CWM COMMENT NUMBER: 82

RMU-2 Waste Disposal  
Department Waste Stream Review Process

Exhibit G, Supplement to Module VI – Landfills [RMU-2]  
Condition E.3.e, Page G-30

**POLYETHYLENE SEAM PROPERTIES**

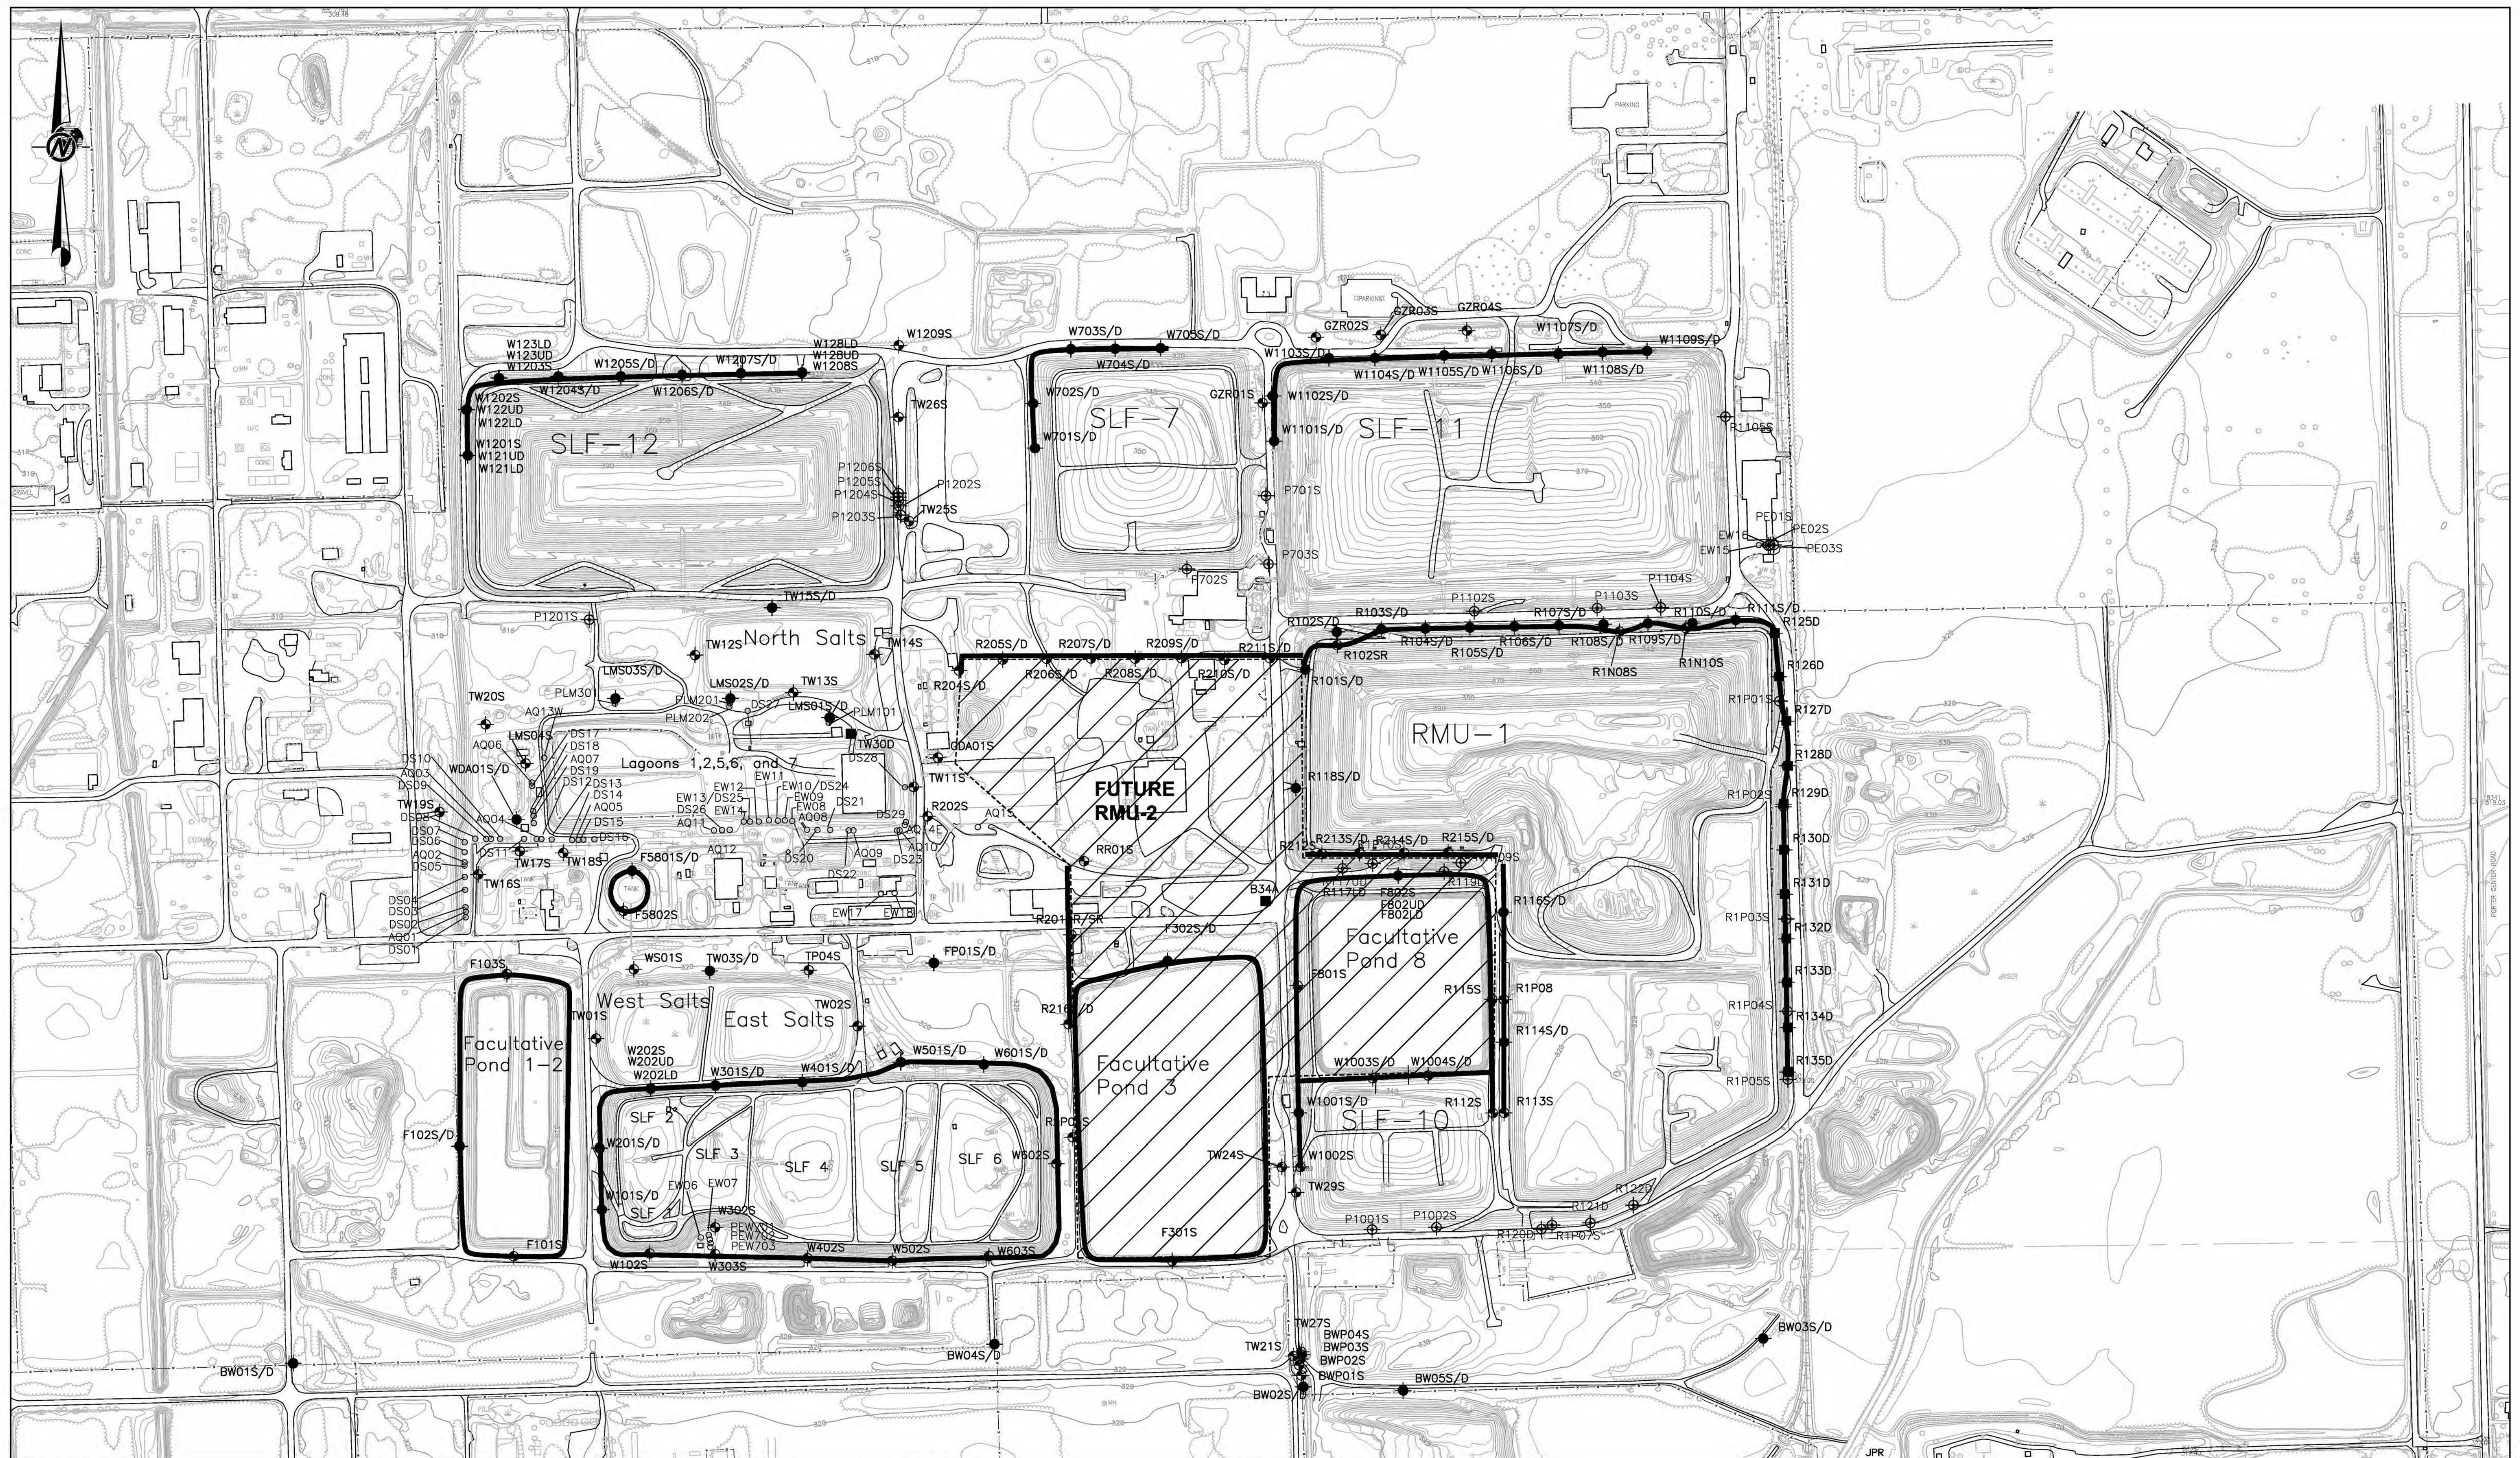
The referenced test method in the table is incorrect. ASTM D4437 is the Standard Practice for Non-Destructive Testing (NDT) for Determining the Integrity of Seams Used in Joining Flexible Polymeric Sheet Geomembranes. The correct method should be ASTM D6392 - Standard Test Method for Determining the Integrity of Non-reinforced Geomembrane Seams Produced Using Thermo-Fusion Methods.

2. Align geomembrane panels to have nominal overlap of 3 in. (75 mm) for extrusion welding and 5 in. (125 mm) for fusion welding. Provide sufficient overlap to allow peel tests to be performed on seam.
3. Use double-fusion welding as primary method of seaming adjacent field panels.
  - a. For cross seam tees, associated with fusion welding, extrusion weld to minimum distance of 4 6 in. (100 mm) on each side of tee.
